**RE: Parking Redesign
2500 Louisiana Blvd NE
Grading & Drainage Plan
Engineer's Stamp Date: 3/12/2026
Hydrology File: H19D095
Case # HYDR-2026-00118**

2500 Louisiana Parking Redesign

C-101

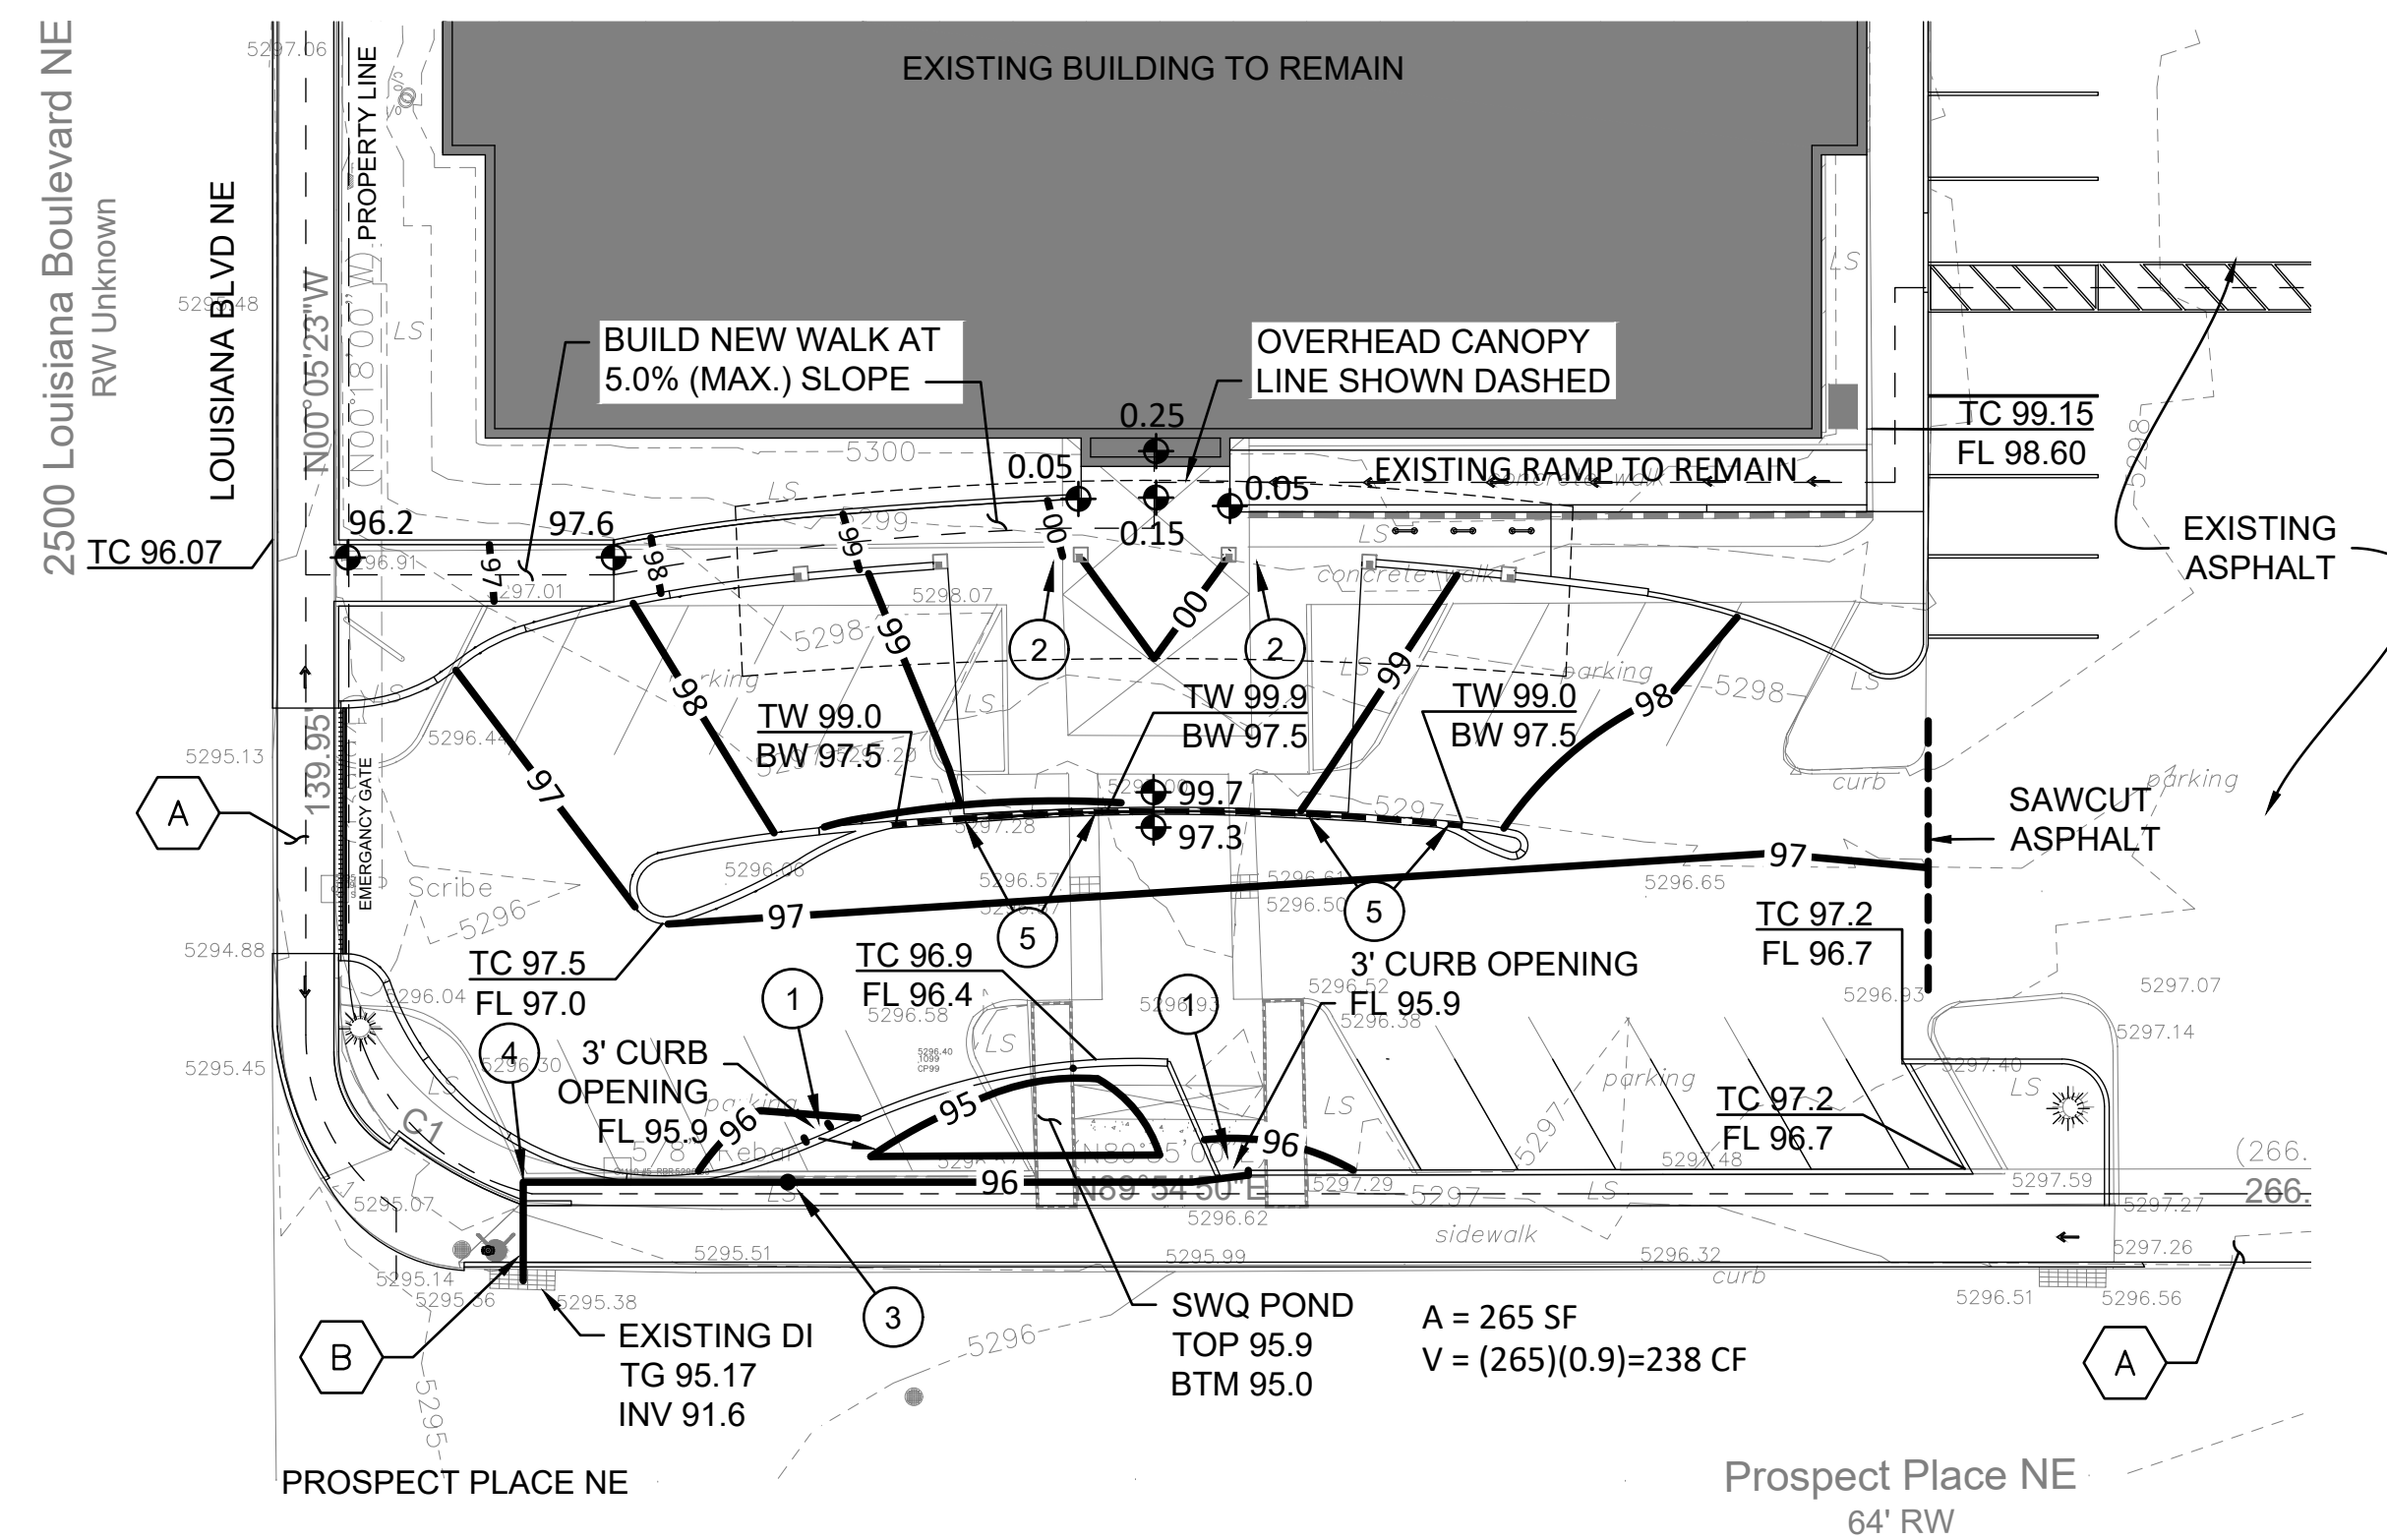
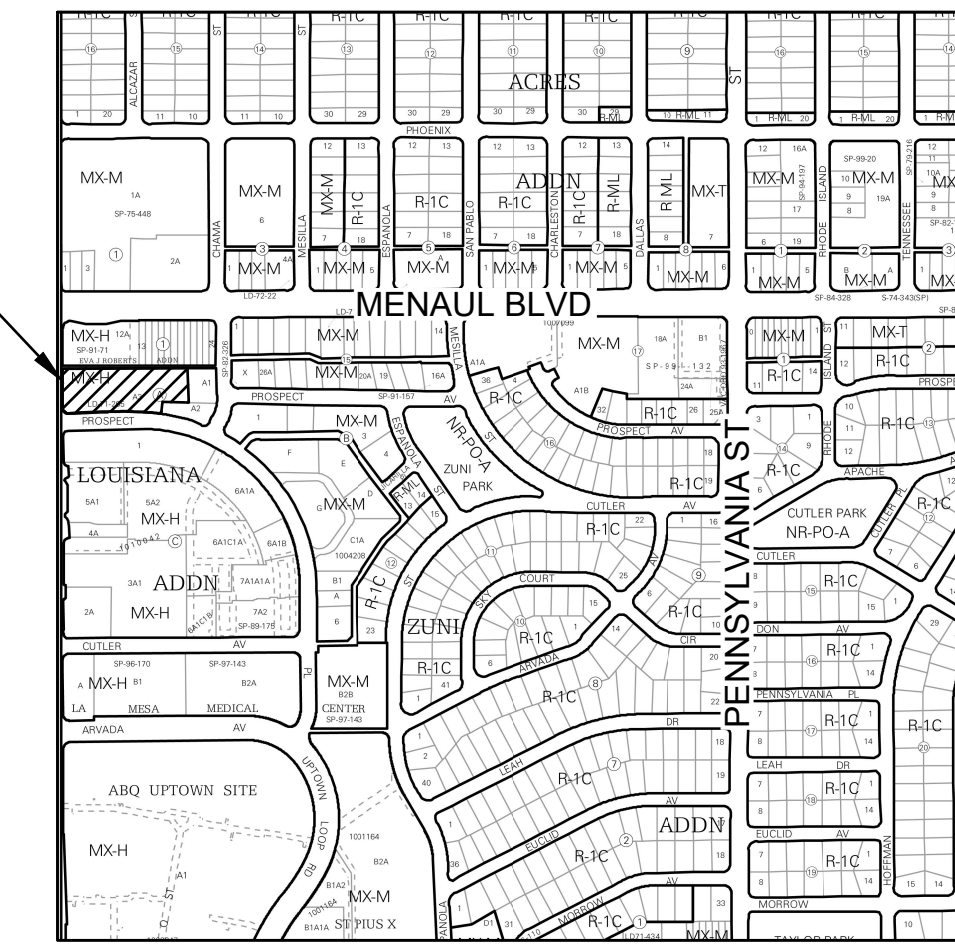
Based upon the information provided in your submittal received 03/30/2025, the Grading and Drainage Plan is approved for Grading Permit, Building Permit and SO-19 Permit. Please attach a copy of this approved plan in the construction sets for Building Permit processing along with a copy of this letter.

1. Engineer's Certification, per the DPM Part 6-14 (F): Engineer's Certification Checklist For Non-Subdivision is required.

2. Please provide the executed paper Drainage Covenant (latest revision) printed on one-side only with Exhibit A and a check for **\$25.00** made out to "Bernalillo County" for the detention pond per Article 6-15(C) of the DPM to Hydrology for review at Plaza de Sol
